Sister Wimberly Playground – Swan Lake

ITB #12 – 25/26

Addendum #2 – October 30, 2025

L1.0

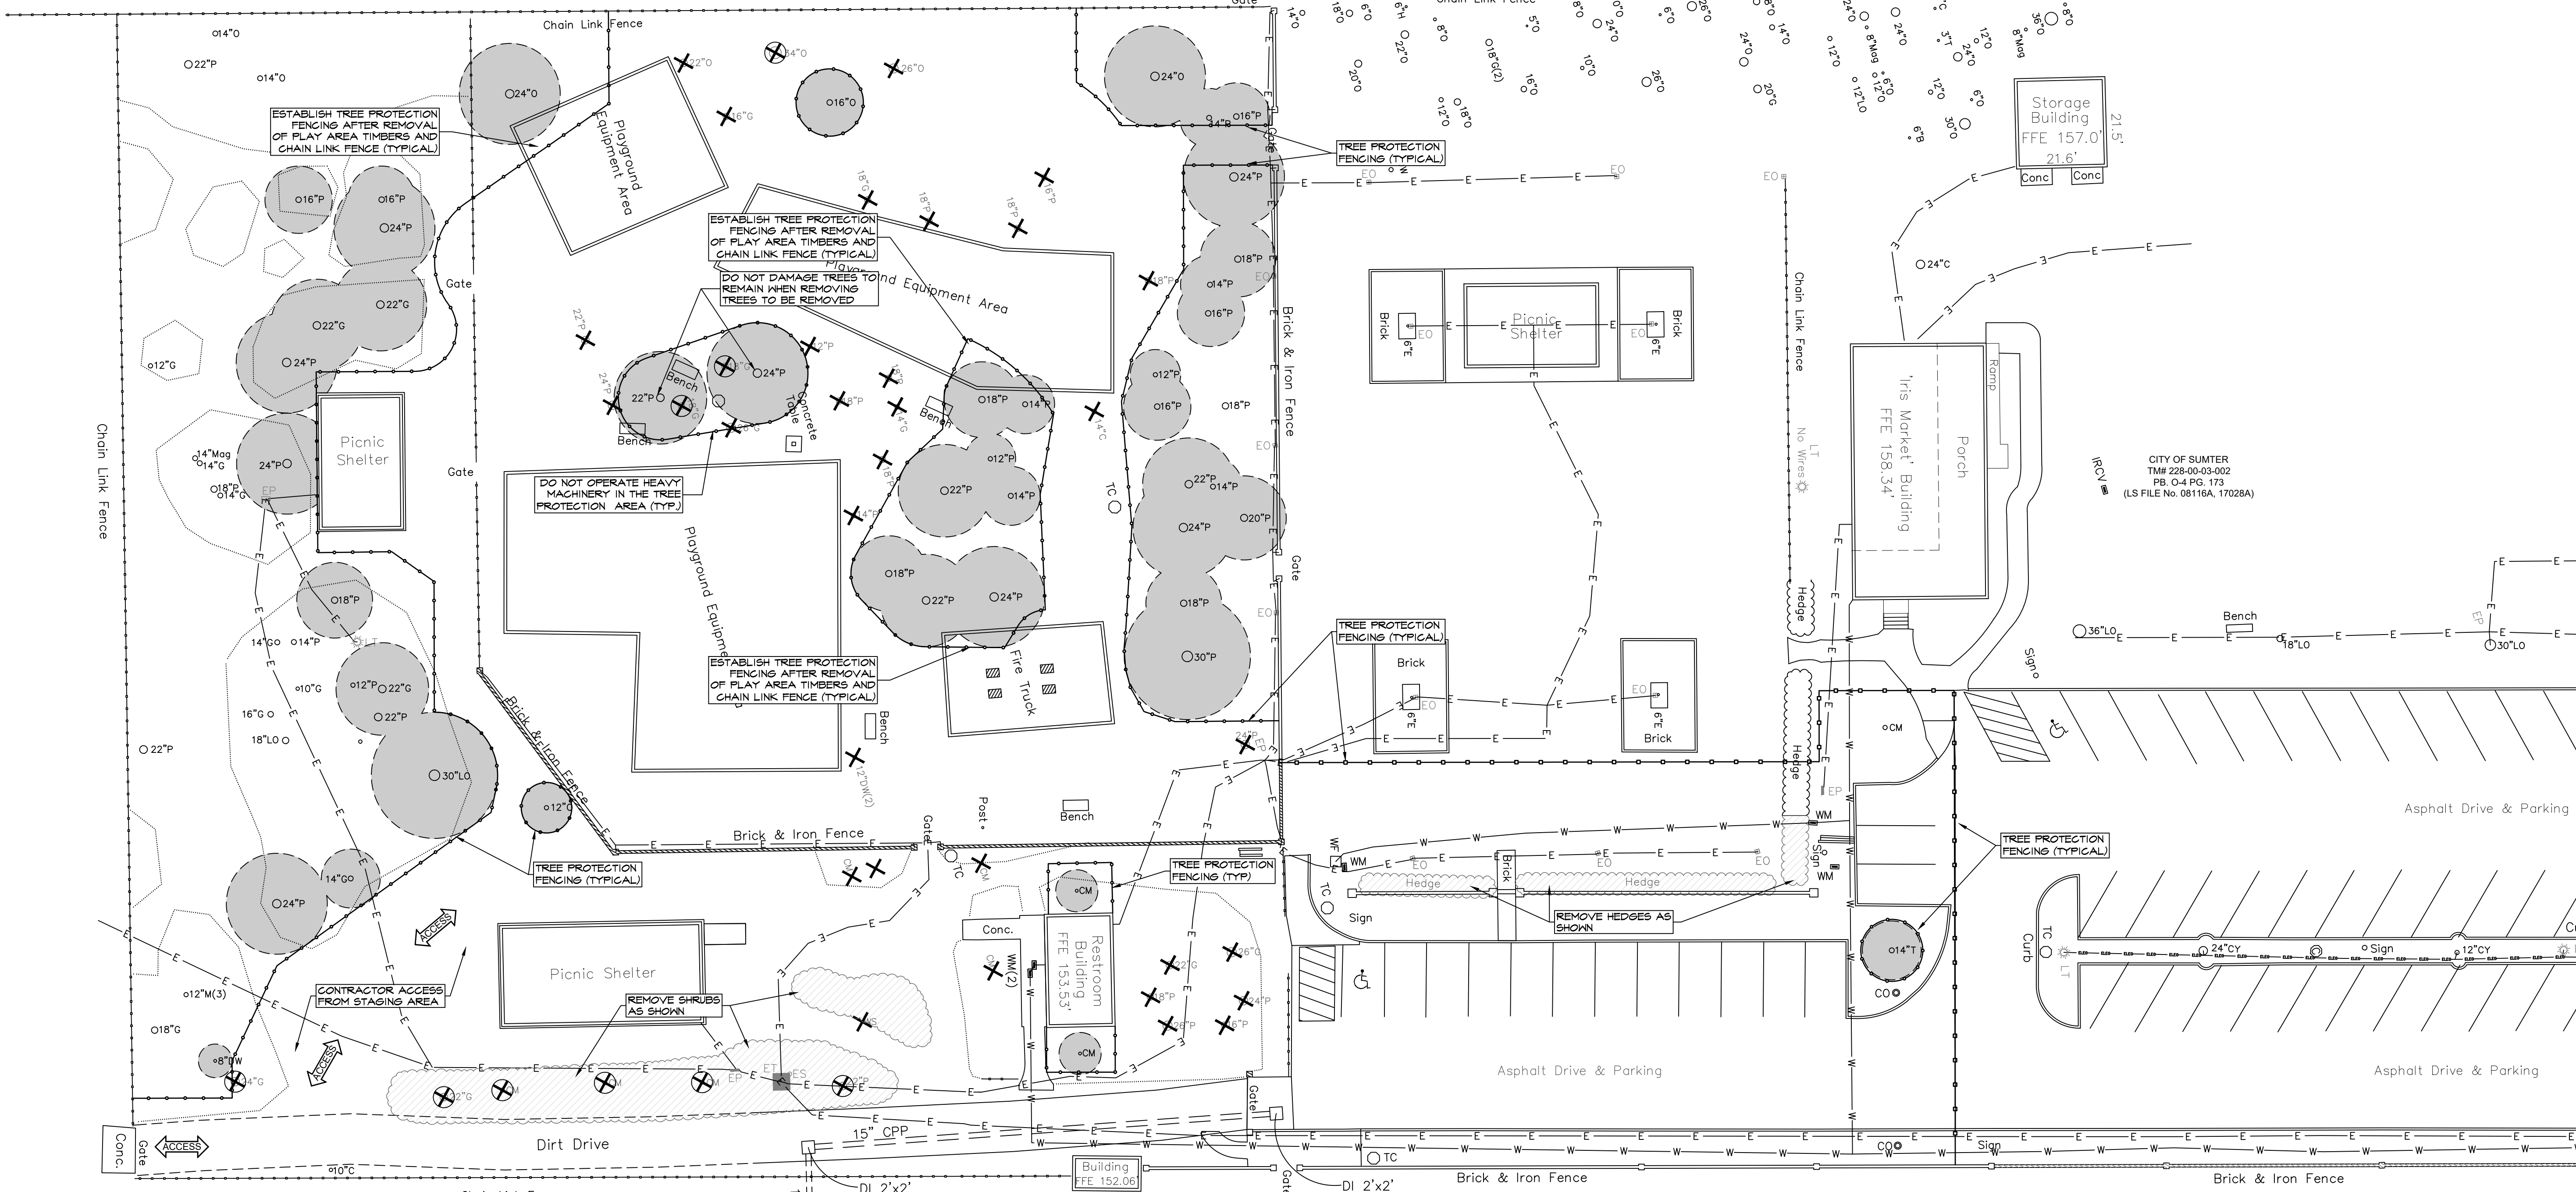
6. Refer to the revised sheet L1.0 and revised tree protection and removal legend and notes on that sheet for additional information on trees to have stumps removed and trees to have stumps ground.

L2.1

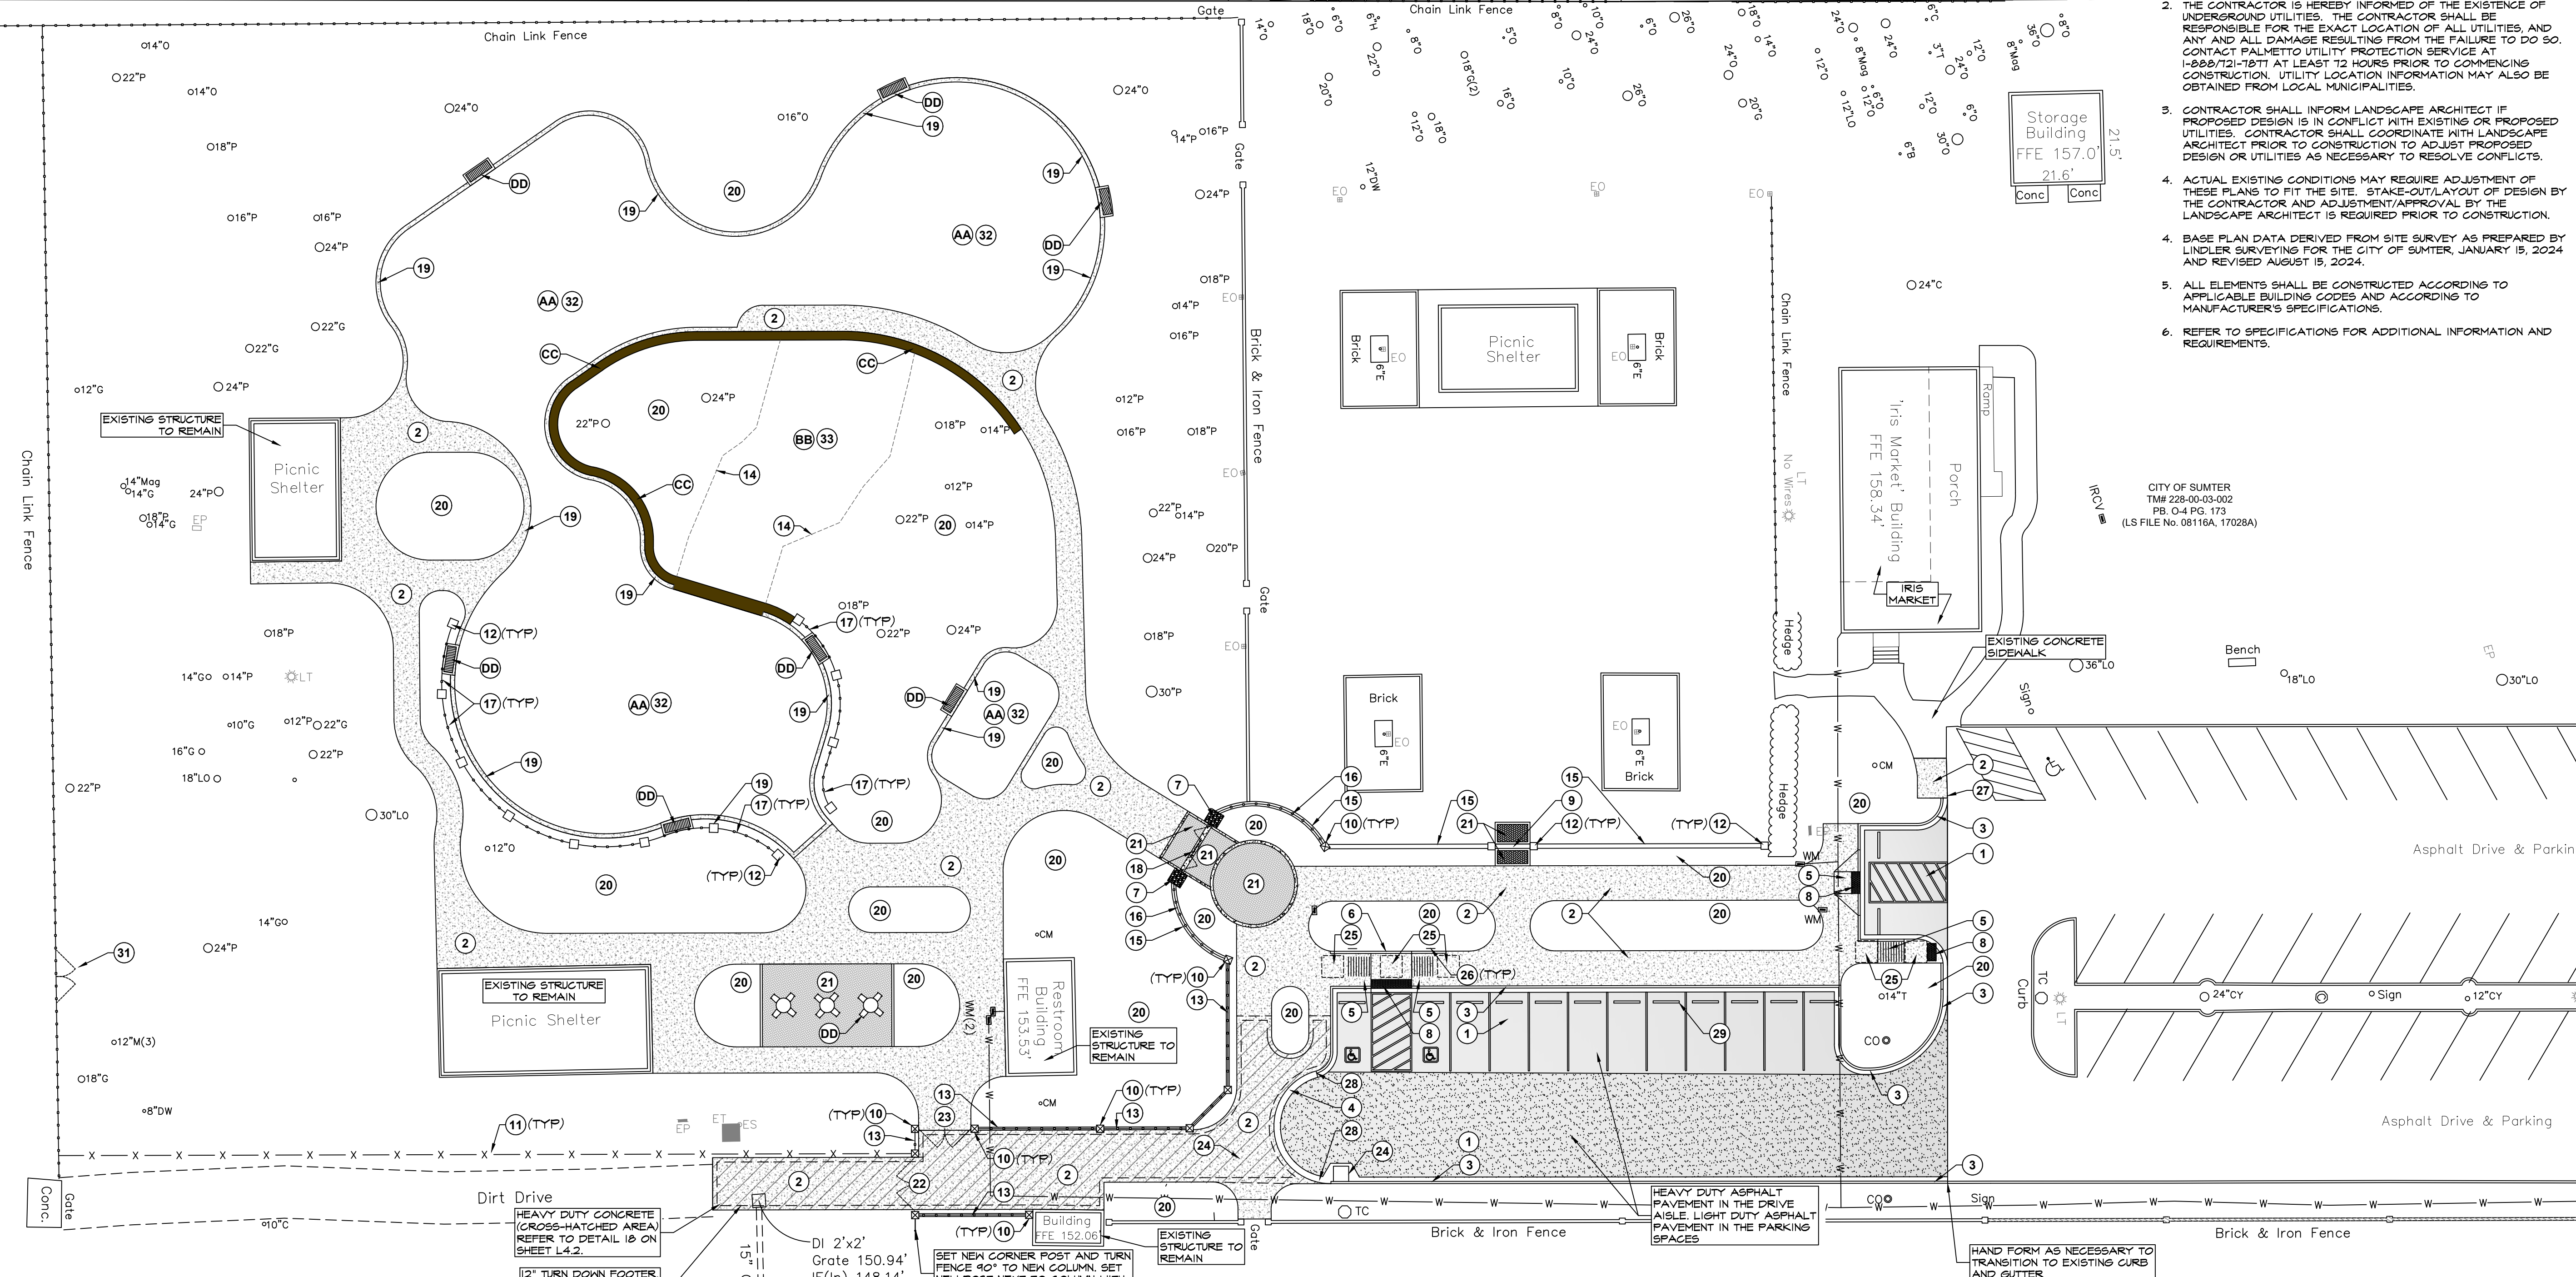
7. Refer to revised sheets L2.1, L2.2 and L4.2 for extended concrete drive along the east edge of the project area and for additional information about heavy duty concrete pavement in that area. The modified area is between the restroom building and the existing utility building to the east and extends approximately from the parking area south to the revised and extended end of the concrete drive.

L6.1

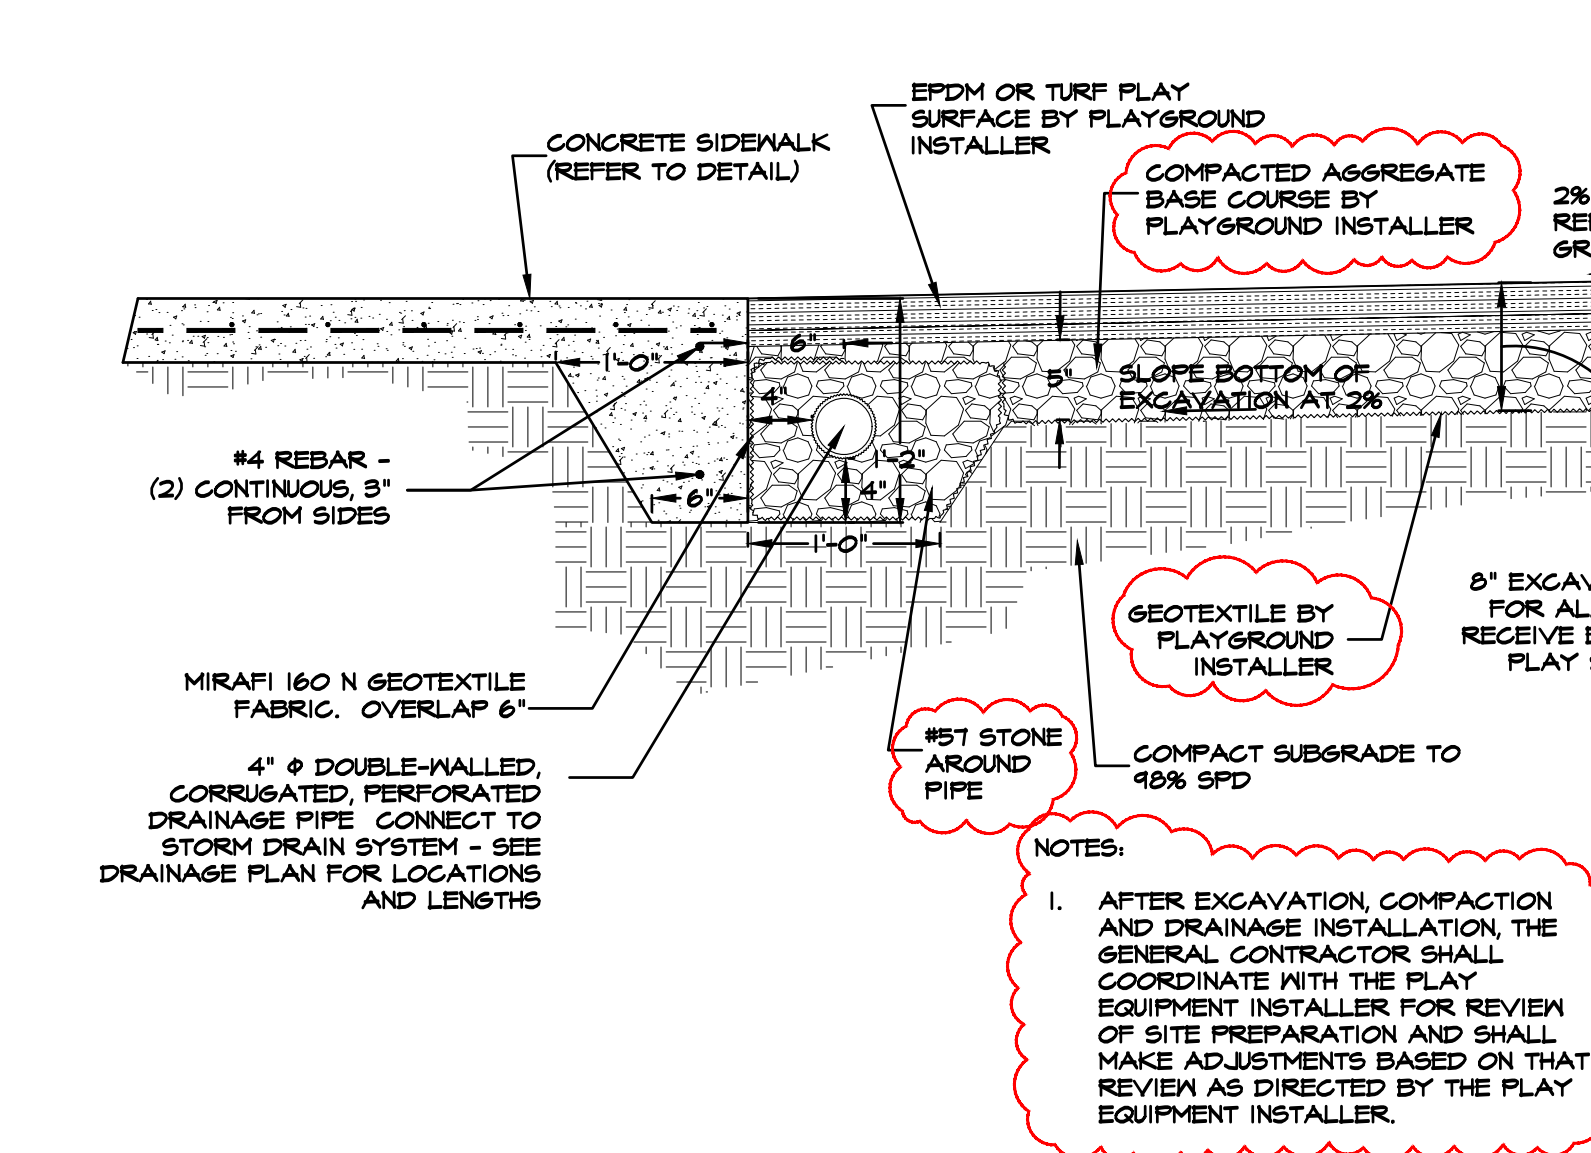
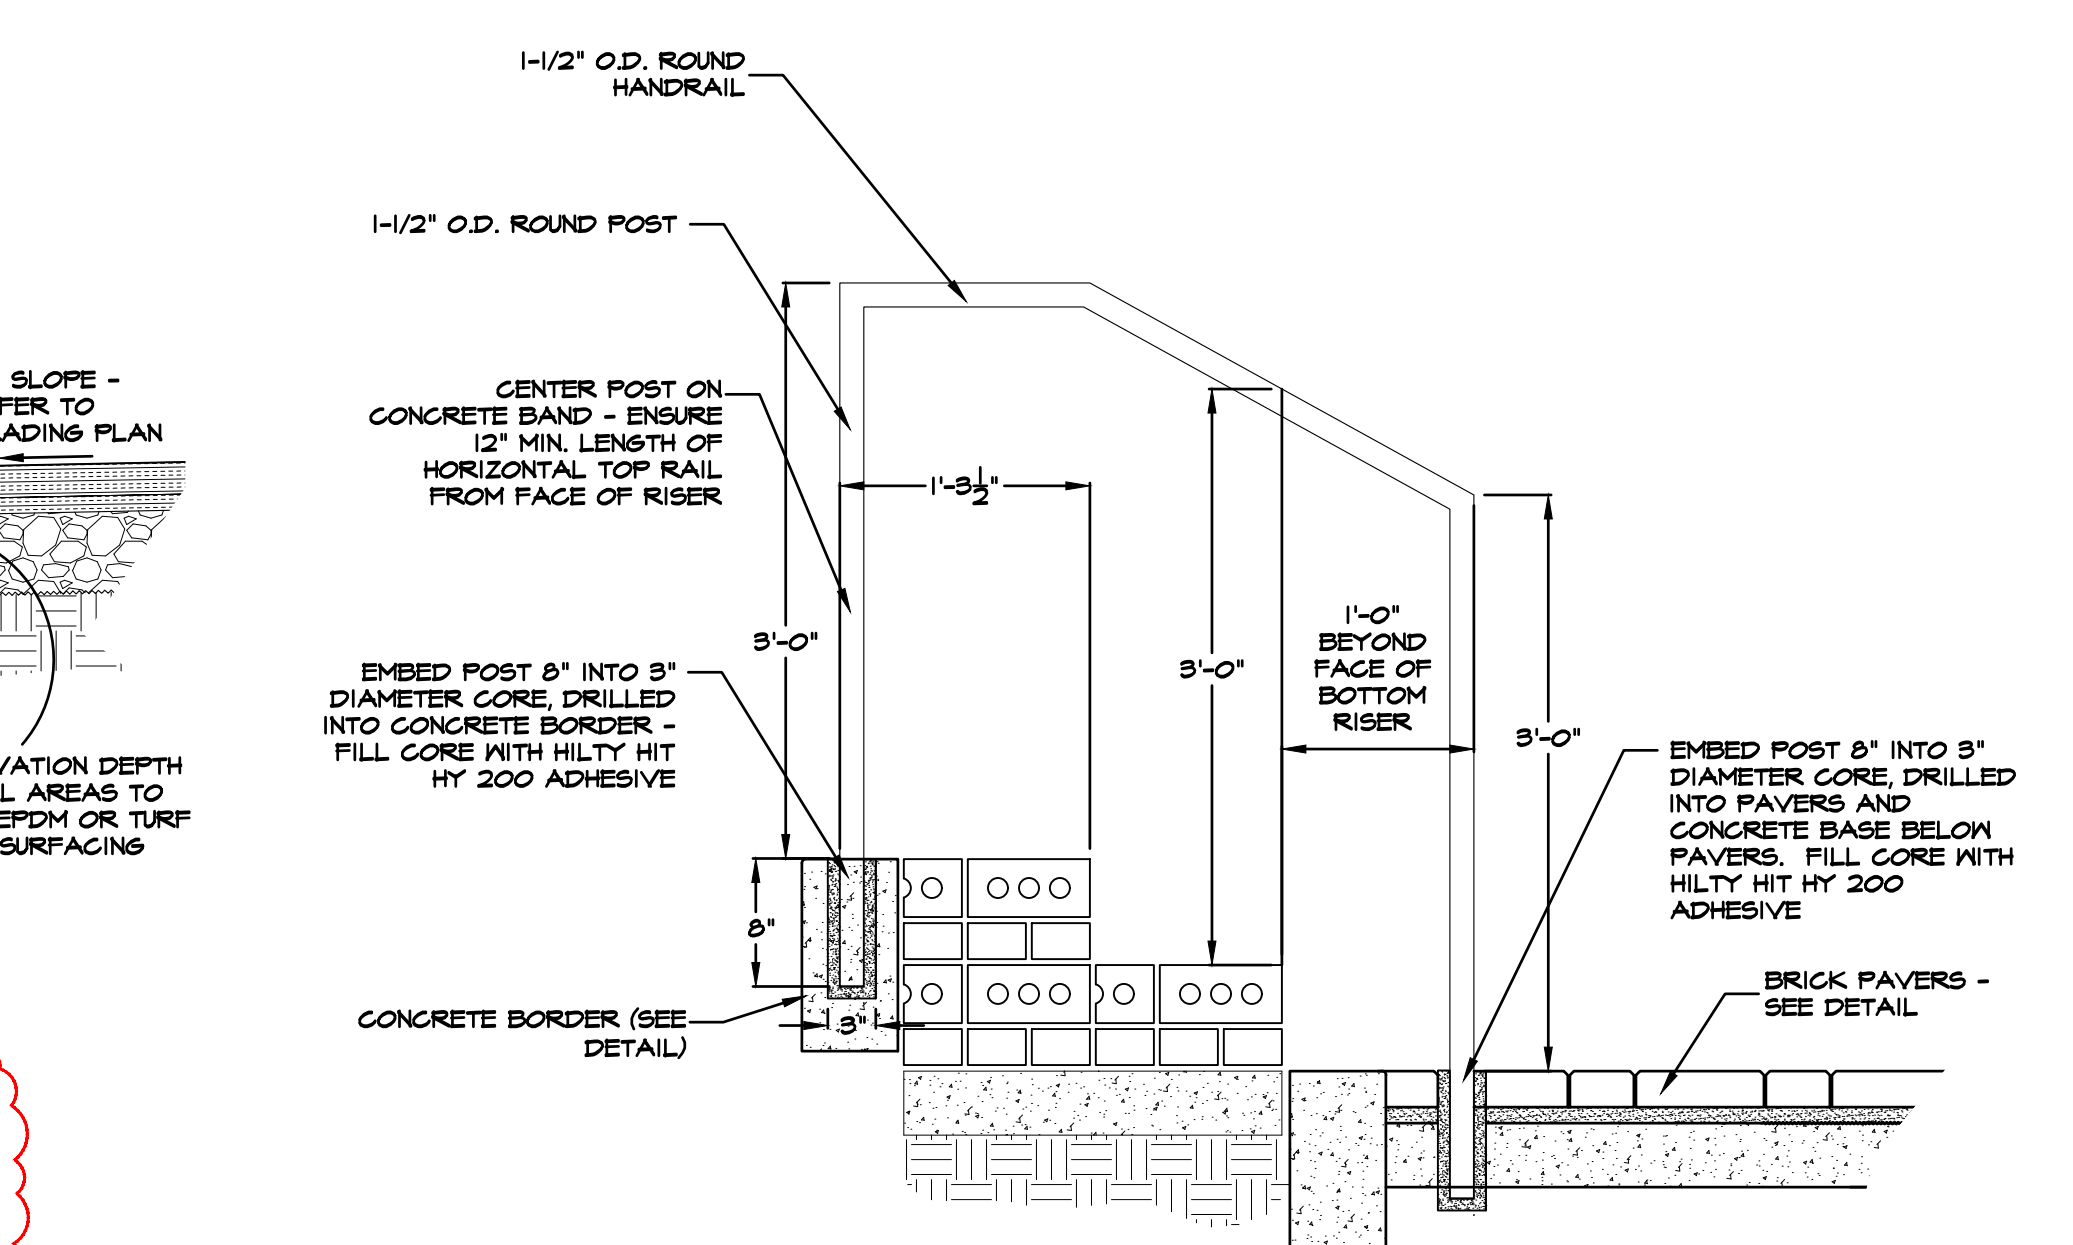
13. Refer to revised details 4 and 5 on sheet L6.1 and detail 2 on sheet L6.4 which clarify that stone below finished playground surfacing is to be installed by the playground installer after excavation and drainage installation by the contractor. Drainage installation by the contractor shall include #57 stone, pipe and geotextile fabric as detailed. Any items not labeled as “BY PLAYGROUND INSTALLER” or “BY OTHERS” shall be installed by the contractor.
